IN THE DRAWINGS:

REMARKS

Fig. 11

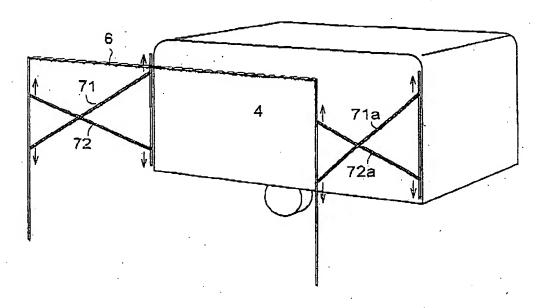
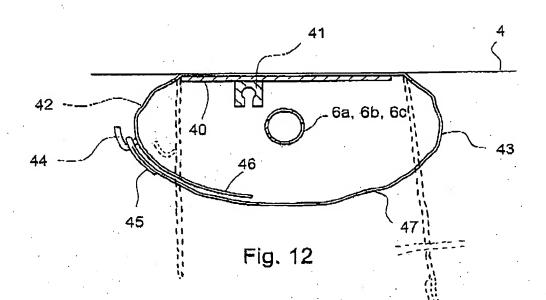
A Letter to the Official Draftsman is attached with proposed drawing corrections to Figures 6A, 12 and 17A.

In the Office Action, the Examiner objected to the drawings under 37 CFR 1.83(a) and 1.84(h)(4). The disclosure in the specification was objected to because it did not contain any headings. Claims 1-6 and 11-16 were rejected under 35 U.S.C. 112, second paragraph, as being indefinite. Claims 1-6 and 15-16 were rejected under 35 U.S.C. 102(b) as being anticipated by Hewlett, in U.S. Patent No. 2,107,608. The Examiner indicated that he would allow claims 12-14 if they were rewritten in independent form.

With reference to paragraph 3 of the Office Action, please note that Figure 1 does show the "container or casing 5" (page 4, line 21 of the specification) and the container clearly is mounted on a camping accommodation. Further, Figures 12, 13 and 14 all do show a casing in mounted condition. Please note that "container" and "casing" are both used to indicate one and the same item, as is clear from page 4, line 21 of the specification. An open position of the container is shown in figure 7 (hinged lid 70 is clearly in open position), figure 15 (see page 11, lines 5-8), figure 17 (page 12, lines 15, 16; flaps 82, 83) and figure 20 (lid 70).

To have the mounted and open positions shown in the figures of the elected species, figure 12 has been amended to show, in broken lines, an open position of strips 42, 43 of a casing for an awning construction.

Fig. 17

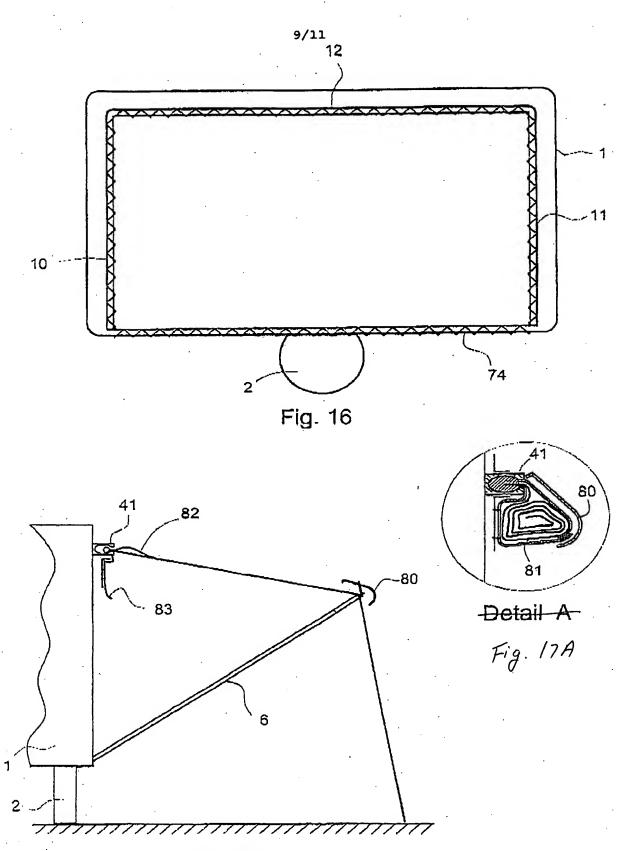
The attached sheets of drawings includes changes to Figs. 6A, 12 and 17A. These sheets, which include Figs. 5, 6, 6A, 11, 12, 16, 17 and 17A, replace the original sheets of Figs. 5, 6, 6A, 11, 12, 16, 17 and 17A.
